PLANNING COMMISSION

201403938

5996 Lake Forrest Drive

DEPARTMENT OF COMMUNITY DEVELOPMENT RECOMMENDATION

SITE PLAN

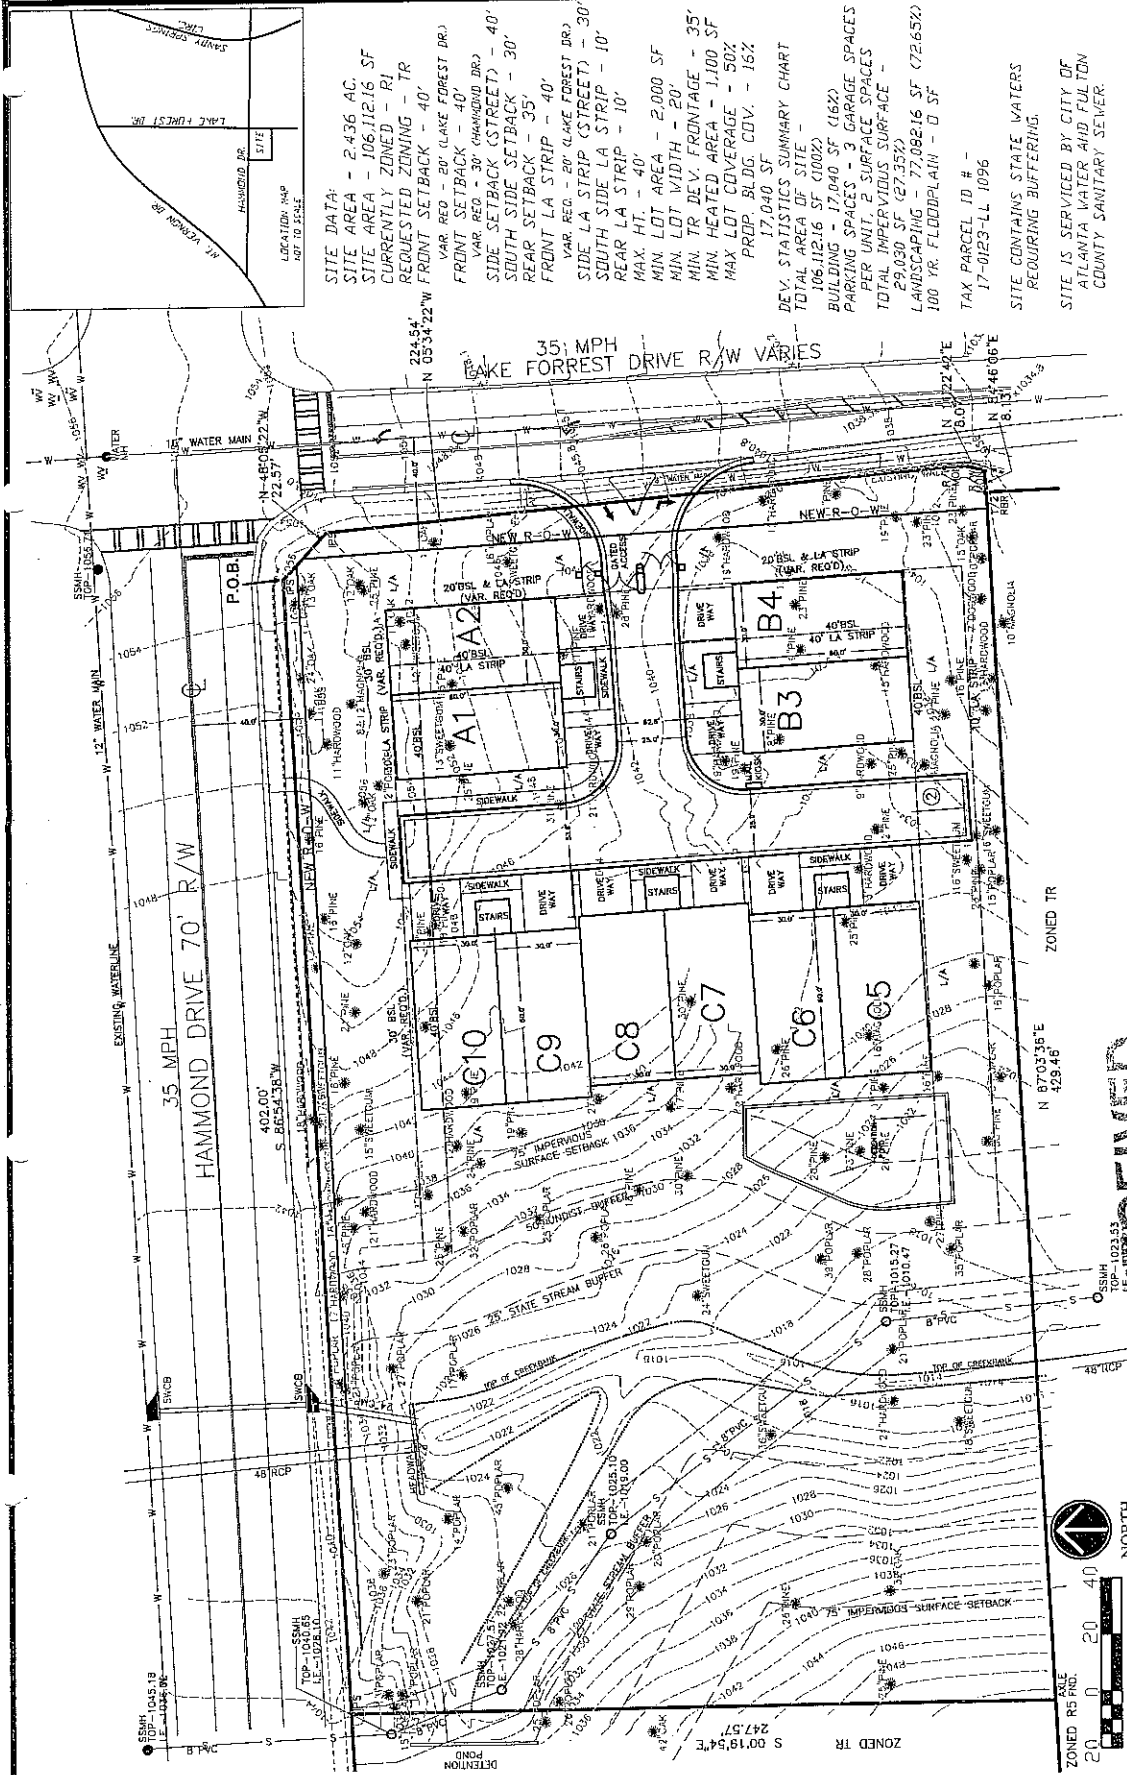
<p><i>Development Ordinance. Based on a review of the zoning site plan, please note the following:</i></p> <ul style="list-style-type: none"> - All proposed streets shall be designed to public street standards §103-70. - The minimum setback for gates in open or closed position is 40 feet from the edge of pavement, and design shall provide for a minimum clear turnaround distance of 20 feet between the vehicular storage and the gate, §103-72. - The minimum right-of-way or shared easement for the proposed street is 50 feet. A 20-foot right-of-way miter is required at intersection of Hammond Drive and Lake Forrest Drive, §103-75. - The minimum lane width for existing streets is 12 feet. - Proposed street access shall meet minimum sight distance of §103-77. - All frontages shall meet curb and gutter requirements, §103-79. <p>Sidewalks are required on both sides of proposed street, §103-80.</p>

Arborist	A variance is required for the construction of the detention pond in the 75' buffer if there is a concrete wall associated with it.

3. To the owner's agreement to provide the following site development standards:
 - a. To reduce the front landscape along Forrest Park Drive from 40 feet to 20 feet;

- b. To reduce the front yard perimeter setback to a street (Forrest Park Drive) from 40 feet to 20 feet;
 - c. To reduce the side setback adjacent to a street (Hammond Drive) from 40 feet to 30 feet;

- d. To apply for and obtain a stream buffer variance if the construction of the detention pond shown on the submitted rezoning site plan involves the construction of a concrete wall or other structure necessitating a stream buffer variance; and

- e. The minimum driveway depth for each townhome unit shall be 18 feet.
